Technical Note

Project:	Havant Reservoir		
Subject:	Response to Local Highway Authority - Northern Access Layout		
Author:	Atkins		
Date:	29/01/2021	Project No.:	5169117
Distribution:	Hampshire County Council	Representing:

Hampshire County Council (HCC), as Local Highway Authority (LHA), have provided formal comments on a number of transport related issues, and the purpose of this Technical Note is to respond specifically to comments pertaining to the layout of the proposed northern access junction. It is intended to serve as a covering Technical Note that will provide additional context and support for a Departure from Standard (DfS) application being submitted to HCC.

Figure -1 - Proposed Layout of Northern Access Junction

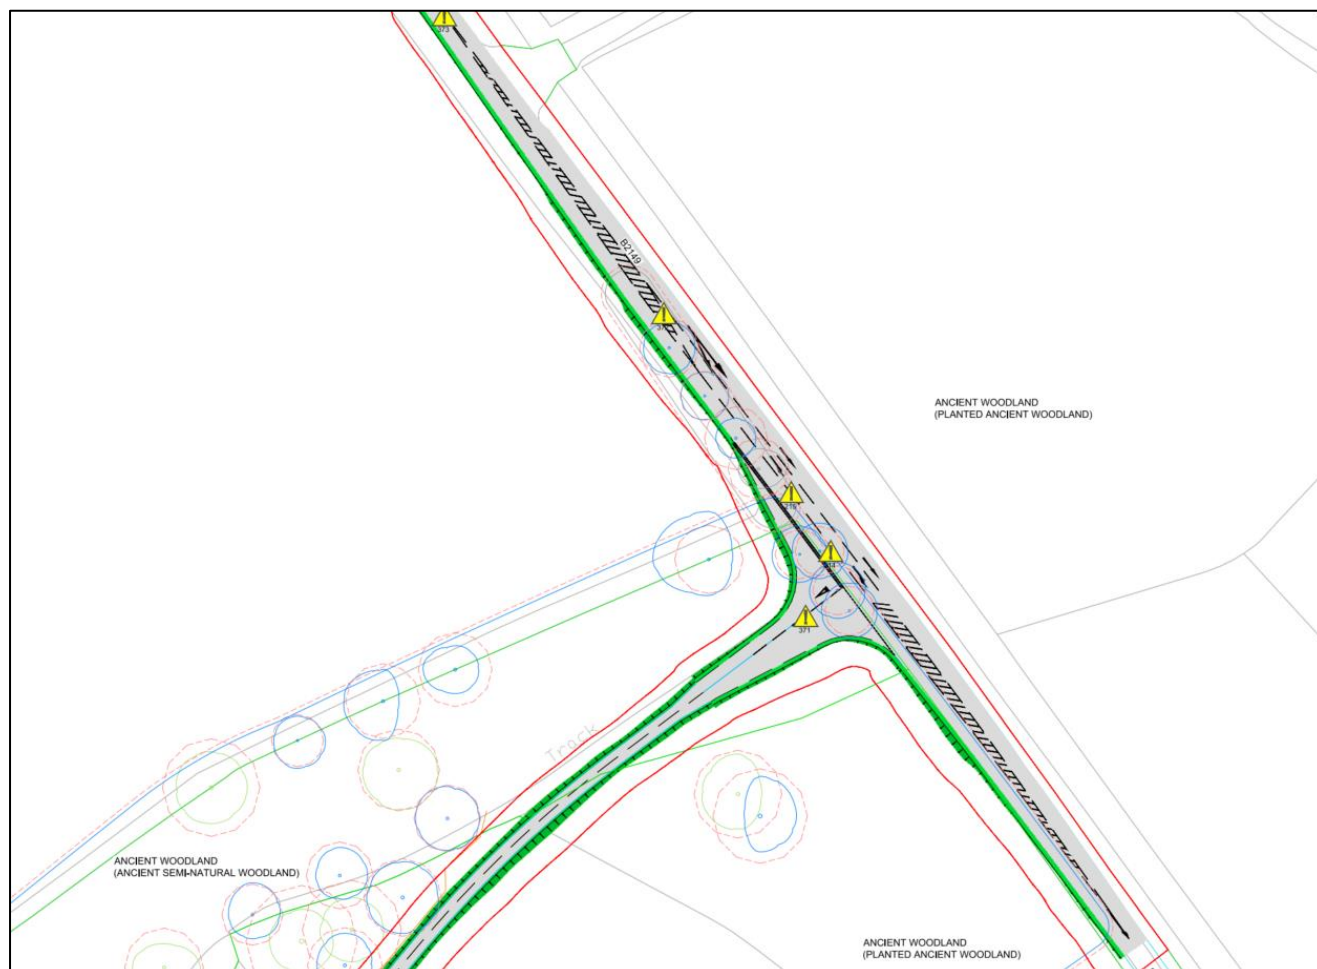
The LHA have stated that *in accordance with DMRB CD123 ghost islands shall only be used where major road traffic flows allow traffic turning right out of the minor road to do so in one manoeuvre. Given average daily flows of above 15,000 on B2149 and addition of 700 daily movements on the access this would mean that Single Lane Dualling should be considered.*

The LHA highlighted that the Road Safety Audit states that drivers who fail to realise there is a junction ahead may attempt to overtake a slower moving vehicle and find themselves on the wrong side of the carriageway as another driver turns out of the site access road resulting in a head-on collision or they may encounter a stationary vehicle in the right turn lane.

The proposed access junction is not clearly visible on the approach when travelling northbound due to the vertical alignment of the B2149, which includes a crest curve to the south of the junction. Because of this, stopping sight distances on both approaches are substandard.

It is proposed to provide a priority junction connecting the proposed northern access route to the B2149, with a right-turn ghost island afforded to vehicle users travelling southbound along the B2149 to access the site. The layout adopted for the junction is in accordance with DMRB CD123 Rev. 1, with the access road adjacent to the junction being 6m in width, tapering down to 3.65 along the main route of the access road (with suitable passing places to allow two-way traffic). 215 metre visibility splays are provided for exiting vehicles in accordance with DMRB CD123 Cl3.6, on the basis of the 60mph speed limit. It should be noted this is in excess of the 160 metres required for the observed 85th percentile speed of 53mph.

With regards to drivers who fail to realise there is a junction ahead attempting to overtake, it should be recognised that the start of the centre double white lines (no overtaking markings) set out in the designer's response, combined with 'No overtaking' and the 'Side road/ destination signs' will inform drivers of the junction, mitigating this risk.
